5569

**PARKING SURFACE AND FRONT LANDSCAPING
VARIANCES TO ALLOW AN AGGREGATE PARKING
SURFACE FOR A TRUCK SALES AND SERVICE CENTER
AND TO REDUCE THE PERCENTAGE OF FRONTAGE
LANDSCAPING IN A B-3, COMMUNITY BUSINESS
DISTRICT; THE ZONING ORDINANCE REQUIRES ALL
PARKING SURFACES TO BE PAVED WITH ASPHALT,
CONCRETE, OR AN APPROVED ALTERNATIVE PAVING
SURFACE, AND REQUIRES AT LEAST 12% OF THE ENTIRE
SITE TO BE LANDSCAPED WITH 60% OF THAT BEING
FRONTAGE LANDSCAPING IN A B-3, COMMUNITY
BUSINESS DISTRICT.**

2223 HALLS MILL ROAD

BOARD OF ZONING ADJUSTMENT

SITE PLAN

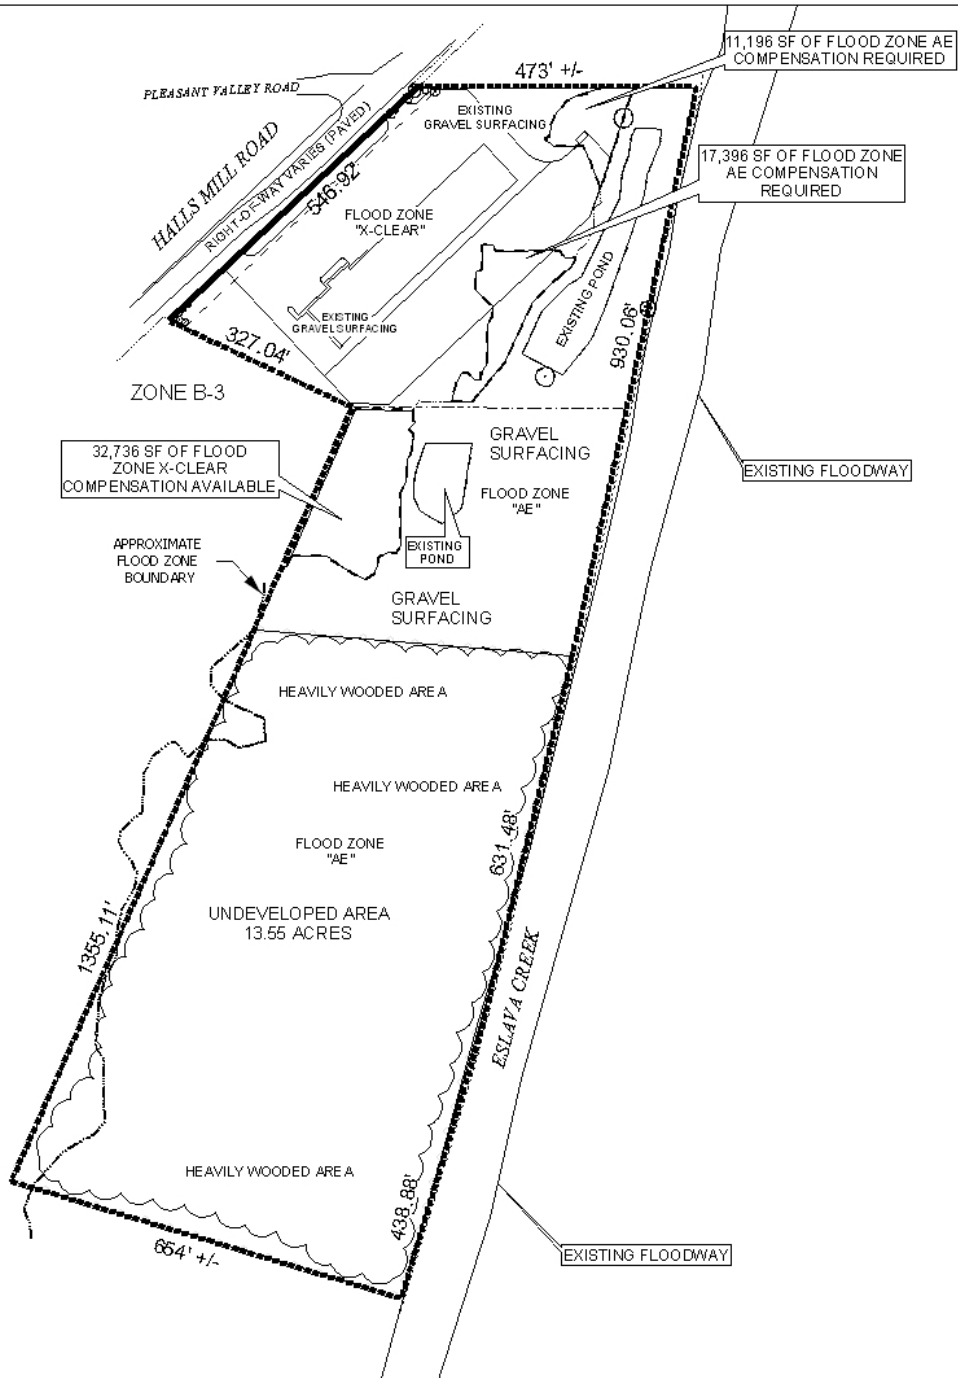
The site currently has gravel surfacing on all access/maneuvering areas. The site plan indicates that the front entrances, and the front, side, and most of the rear parking/access/maneuvering areas will be paved in compliance with concrete. However, the access/maneuvering area immediately behind the building for the service bays is proposed to be stone-paved, and the remaining truck and equipment parking area to the rear of that is proposed to remain gravel surfacing. The applicant states that when flood levels exceed the 100-year "Base Flood Elevation", the rear parking area will be submerged and it is believed that pavement failure could occur.

Due to the fact that much of the rear of the site is located within a flood zone, the 388' long office and service building is proposed to be parallel with and closer to the front property line. With the larger maneuvering area required in the front for the trucks to enter and exit the service bays in the building, insufficient area remains to provide the total required frontage landscaping area. The total site area proposed to be developed is 487,002 square feet which requires 35,064 square feet of frontage landscaping; however, 25,085 are proposed. However, a review of the site plan and building dimensions indicates that the building could be re-oriented perpendicular to the front property line at the 25' building setback line and extend toward the rear of the property approximately 354' before entering a flood zone. With the elimination of the Western 34' of office space on the ground floor and building a second story for offices, the building could be located on the site to avoid the flood zone and still provide adequate maneuvering area for trucks, standard vehicle parking, and the required frontage landscaping.

Frontage tree calculations on the site plan should be revised to indicate 18 trees required. Existing pear trees are not considered to be over-story trees and, therefore, cannot be used

as frontage tree credits, but could be used as under-story perimeter credits. As eleven new Live Oaks are proposed and there are overhead power lines along the frontage, seven more Live Oaks must be included in the frontage calculations, for a total of 18 Live Oaks along the front.

The site plan does not indicate the 25' natural vegetative buffer along the rear of the property bordering Eslava Creek which was a condition of approval of the subdivision for the site, Cross-Pond Subdivision. That condition stated "provision of a 25' minimum buffer strip along the South and East property lines, to be maintained in a natural vegetative state with supplemental plantings as necessary to sufficiently screen the site from adjacent residential properties". The recorded plat indicates such a buffer strip. However, site photographs provided with the application indicate that the buffer is not completely provided or being maintained as stipulated. Therefore, the buffer should be provided and maintained along Eslava Creek (the East property line of the site) as previously conditioned. The South property line of the site is on the large wooded area which is not proposed to be developed at this time.

Also, the photographs provided indicate barbed wire fencing around much, if not all, of the site. Under Section 21-1 of the City Code chapter "Fences, Barricades and Similar Structures," the City has permitted barbed wire fences by special permission of the Director of Urban Development in B-3 Districts, among others. No permit for the fence is found in the permitting database; therefore, the applicant should either provide proof of permitting for the fence or submit an application for the approval of the existing fence.

Based on the preceding, the parking surface variance request is recommended for approval, subject to the following conditions:

- 1) revision of the frontage tree calculations to indicate 18 Live Oak trees required along the frontage;
- 2) provision of a 25' natural vegetative buffer along the East property line adjacent to Eslava Creek, to be maintained in a natural vegetative state with supplemental plantings as necessary to sufficiently screen the site from adjacent residential properties, to be coordinated with Urban Forestry;
- 3) submission of evidence that the barbed wire fencing was permitted, or the obtaining of an after-the-fact permit for such from the Director of Urban Development; and
- 4) full compliance with all other municipal codes and ordinances.

The frontage landscaping variance request is recommended for denial.
